Access Compliance Report

Public Rights-of-Way

(Curb Ramps)

Intersection ID: 13829	Main Street: E_MOREHEAD_ST	Cross Street: DILWORTH_RD	Location: E
ADA ID: 819F8D2C699D	Ramp Type: PerpDiag	Initial Pass/Fail: Fail	Overall Compliance: No
Codes/Mitigation Info/Possible Solution		Field Measurements/Component Compliance	
Severity Score: 21.25

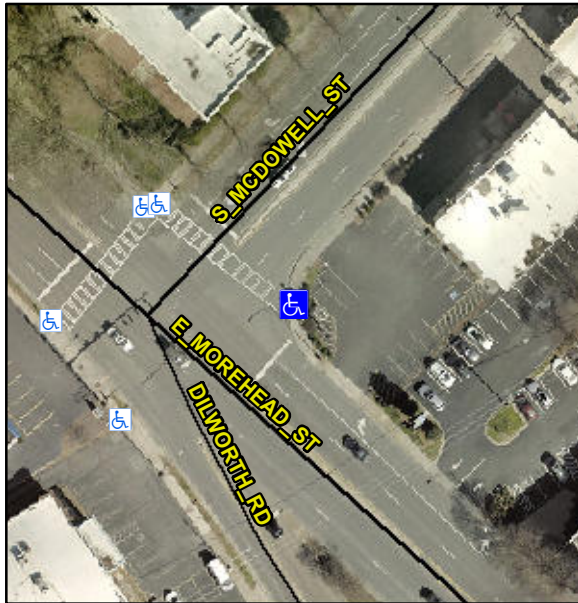
Compliance	Description	Data	Compliance	Description	Data
N/A	Ramp Length (in)	80.0	No	Ramp Slope (%)	8.8
No	Ramp Width (in)	45.0	Yes	Ramp XSlope (%)	1.1
N/A	Flare Type LT	N/A	N/A	Flare Type RT	N/A
N/A	Flare Slope LT (%)	N/A	N/A	Flare Slope RT (%)	N/A
N/A	Flare Traversable LT?	N/A	N/A	Flare Traversable RT?	N/A
N/A	Landing Length (in)	N/A	N/A	DWS Provided?	N/A
N/A	Landing Width (in)	N/A	N/A	DWS Contrast?	N/A
N/A	Landing Slope (%)	N/A	N/A	DWS Length (in)	N/A
N/A	Landing X Slope (%)	N/A	N/A	DWS Full Width?	N/A
N/A	Landing Curb? (Y/N)	N/A	N/A	DWS Offset (in)	N/A
N/A	Shared Landing?	N/A			
N/A	Gutter Ponding?	Yes	N/A	Gutter Slope (%)	N/A
N/A	Gutter Lip Ht (in)	N/A	N/A	Gutter X Slope (%)	N/A
N/A	Painted X Walk1?	Yes	N/A	Painted X Walk2?	No
	X Walk 1 Direction	To NW		X Walk 2 Direction	To W
N/A	X Walk 1 Width (in)	92.0	N/A	X Walk 2 Width (in)	N/A
	X Walk 1 Slope (%)	4.7		X Walk 2 Slope (%)	2.9
	X Walk 1 X Slope (%)	1.5		X Walk 2 X Slope (%)	2.6

N/A	Ramp inside XWalk1?	Yes	N/A	Ramp inside XWalk2?	N/A
	Road Slope (%)	1.3	N/A	Clear Space?	N/A
	Road X Slope (%)	3.5	N/A	Clear Space to XWalk (in)	N/A
N/A	Any Obstructions?	N/A	N/A	Storm Grate/Utility Hazard?	N/A
	Obstruction Type			Storm Grate/Utility Type	
		N/A			N/A
		Yes		Surface Condition? (G/P)	Good

Remove & Replace Curb Ramp With Two New Directional Ramps or Equivalent.

R304.5.1, R304.2.2
